Vermeer MV Solutions, Inc.

FIELD CAMPAIGN KIT #: VMV000097

For Dealer Reference: Service Bulletin #: SMV2025-006

Debris Tank Door Retention Clip Replacement Kit

Procedure 1: Retaining Clip Information

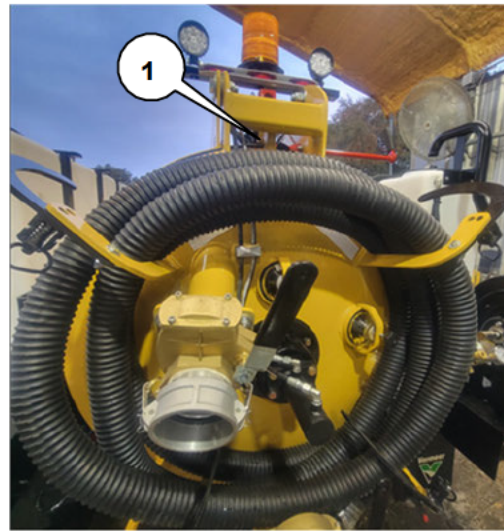
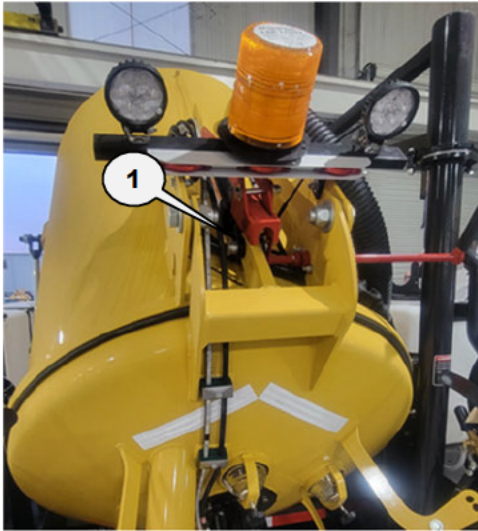
1. Retaining clip location.

2. Current retaining clip are R-Type Spring Cotter pins, also known as Hair Pin Style Cotter Pins.

3. Replacement retaining clip is a rue clip.

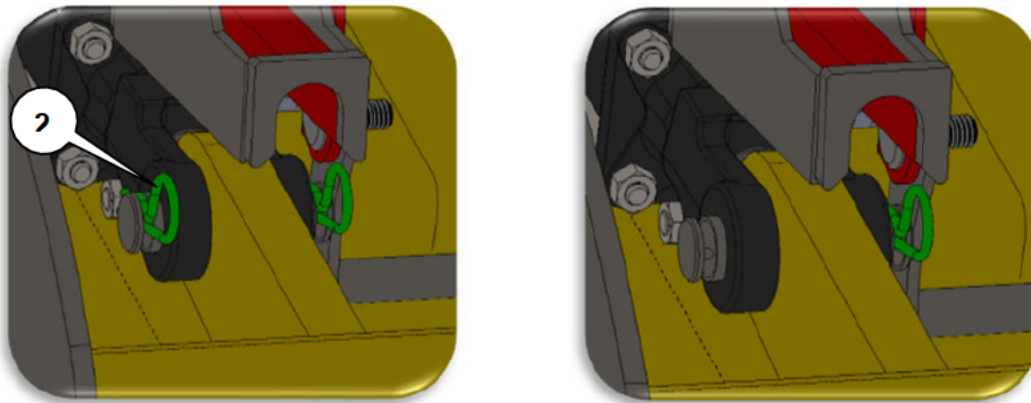
2. Remove one of the R-Type Spring Cotter pins (shown in green.)

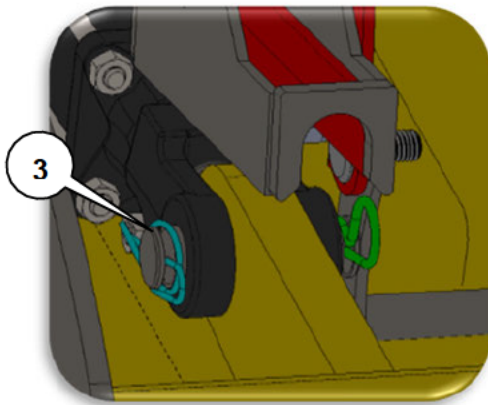
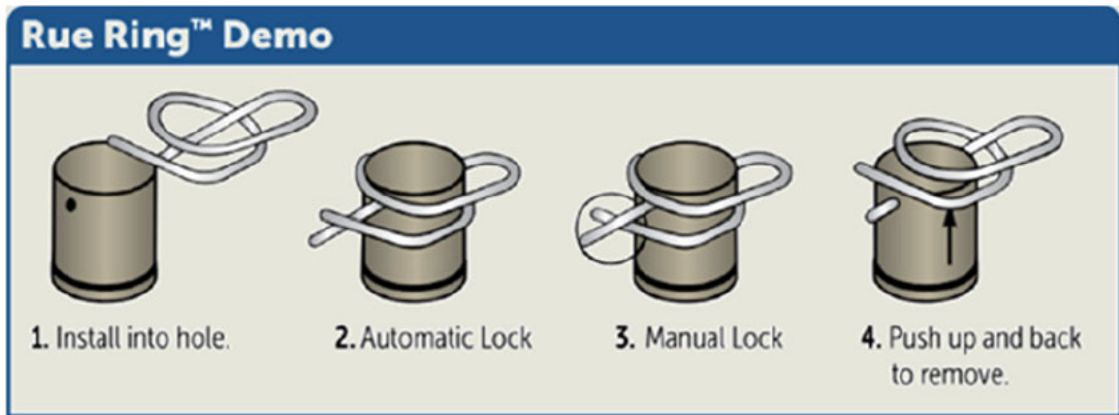
3. Insert one of the Rue Clips in place of the R-Type Spring Cotter pin until it is fully seated.
